Access Compliance Report Public Rights-of-Way (Curb Ramps)

Main Street: SILVER_FOX_RD Cross Street: GLENROY_PL Location: SW

ADA ID: RPAT211202143744 Ramp Type: Type 1 - Perpendicular Diagonal Initial Pass/Fail: Pass Overall Compliance: No Severity Score: 16

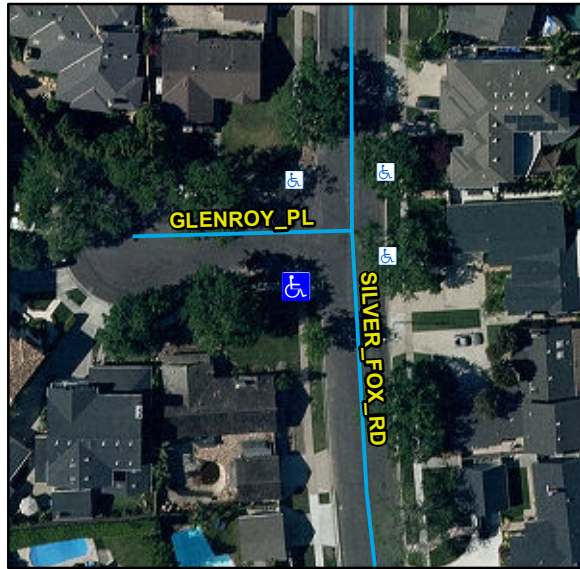
R304.2.2, R204.3, R304.2.1, R304.5.3, R305, R302.7, STD 1115

Remove & Replace Curb Ramp With Two New Directional Ramps or Equivalent.
